COMBS PLACE SUBDIVISION

Revised for the December 15th meeting:

APPLICATION NUMBER Holdover DATE December 15, 2005		- N
APPLICANT	Combs Place Subdivision	- ∯
REQUEST	Subdivision	₋
-		NTS

DETAIL SITE PLAN

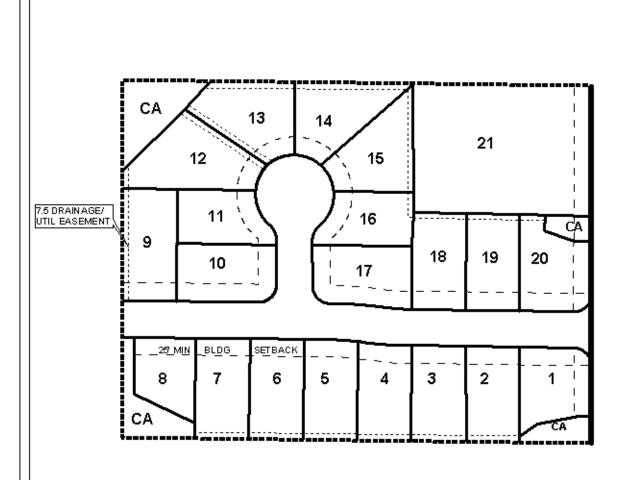
As a means of access management, the placement of a note on the final plat stating that Lots 10 and 17 (which are corner lots) are limited to one curb cut each, with the size, location and design to be approved by Traffic Engineering and Lots 1 and 20 are denied direct access to Grider Road should be required. Additionally, any new roads for the site are to be constructed dedicated and dedicated to meet City of Mobile standards.

As the site adjoins a large undeveloped parcel to the West, a street stub is provided to the West. Furthermore, the adjacent vacant parcel to the West is currently owned by the City of Mobile.

Common areas are shown on the plat, thus a note should be placed on the final plat stating that maintenance of all common areas will be the responsibility of the property owners. Access to these areas will be via a 7.5' drainage and utility easement.

The 25-foot minimum building setback lines are not shown but would be required on the final plat.

This application was heldover from the Commission's November 17th meeting until the December 15th meeting to allow the City Engineering Department to provide additional information about the construction standards of Grider Road. At the time of mailout, the information provided to the applicant is as followed: "Grider Road was not constructed to City of Mobile standards (no curb and gutter and no underground drainage) and the asphalt is in poor condition with a width of only 17 – 17.5 feet". This would not make Grider Road even comply with private road standards. Furthermore, the proposed 21 lots plus the potential for future subdivision of the property to the West may be excessive for the existing roadway condition. Therefore, the application is recommended for denial.

The plat meets the minimum requirements of the Subdivision Regulations and is recommended for Tentative Approval subject to the following conditions: 1) construction and dedication of new roads to meet City of Mobile standards; 2) the placement of a note on the final plat stating that Lots 10 and 17 (which are corner lots) are limited to one curb cut each, with the size, location and design to be approved by Traffic Engineering and Lots 1 and 20 are denied direct access to Grider Road; 3) the provision of a street stub to the West as shown on plat submitted; 4) the placement of a note on the final plat stating that maintenance of all common areas are the responsibility of the property owners; 5) the placement of the 25-foot minimum setback lines on the final plat; 6) full compliance with Urban Forestry comments (Preservation status is to be given to the 35" Live Oak Tree located on the North side of Lot 19. Any work on or under this tree is to be permitted and coordinated with Urban Forestry; removal to be permitted only in the case of disease or impending danger); and 7) full compliance with City Engineering comments (A Hold Harmless agreement will be required for discharge from the stormwater detention pond(s). The Hold Harmless agreement must be from all affected property owners for increased and/or concentrated stormwater runoff. Grider Road was not constructed to City of Mobile standards (no curb and gutter and no underground drainage) and the asphalt is in poor condition with a width of only 17 - 17.5 feet. Development must comply with all stormwater and flood control ordinances. Any work performed in the right-of-way will require a right-of-way permit).
